Access Compliance Report

Public Rights-of-Way

Intersection ID: 30447	Main Street: GRAPEYARD_CT	Cross Street: CADES_COVE_DR	Location: NE
ADA ID: E40BB7471C82	Ramp Type: PerpDiag	Initial Pass/Fail: Fail	Overall Compliance: No
		Severity Score: 10

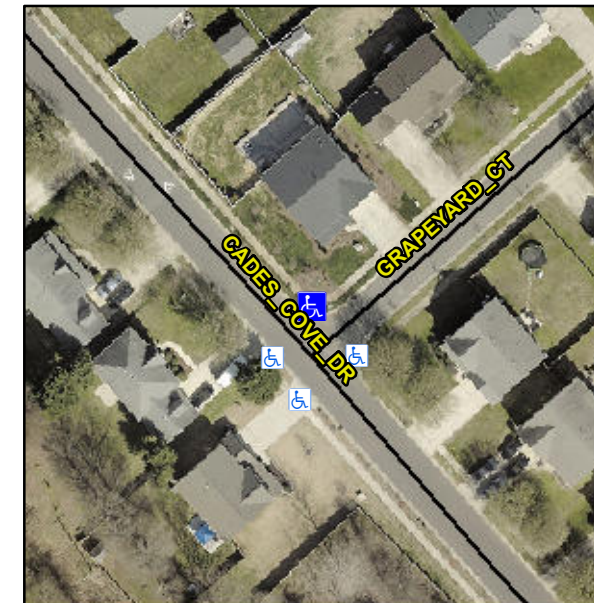
Compliance	Description	Data	Compliance	Description	Data
N/A	Ramp Length (in)	46.5	Yes	Ramp Slope (%)	5.3
No	Ramp Width (in)	44.0	No	Ramp XSlope (%)	2.8
N/A	Flare Type LT	N/A	N/A	Flare Type RT	N/A
N/A	Flare Slope LT (%)	N/A	N/A	Flare Slope RT (%)	N/A
N/A	Flare Traversable LT?	N/A	N/A	Flare Traversable RT?	N/A
N/A	Landing Length (in)	N/A	N/A	DWS Provided?	N/A
N/A	Landing Width (in)	N/A	N/A	DWS Contrast?	N/A
N/A	Landing Slope (%)	N/A	N/A	DWS Length (in)	N/A
N/A	Landing X Slope (%)	N/A	N/A	DWS Full Width?	N/A
N/A	Landing Curb? (Y/N)	N/A	N/A	DWS Offset (in)	N/A
N/A	Shared Landing?	N/A			
N/A	Gutter Ponding?	N/A	N/A	Gutter Slope (%)	N/A
N/A	Gutter Lip Ht (in)	N/A	N/A	Gutter X Slope (%)	N/A
N/A	Painted X Walk1?	No	N/A	Painted X Walk2?	No
	X Walk 1 Direction	To SW		X Walk 2 Direction	To SE
N/A	X Walk 1 Width (in)	N/A	N/A	X Walk 2 Width (in)	N/A
	X Walk 1 Slope (%)	1.9		X Walk 2 Slope (%)	1.5
	X Walk 1 X Slope (%)	0.6		X Walk 2 X Slope (%)	0.9

Remove & Replace Curb Ramp With Two New Directional Ramps or Equivalent.

R304.5.1, R304.5.3
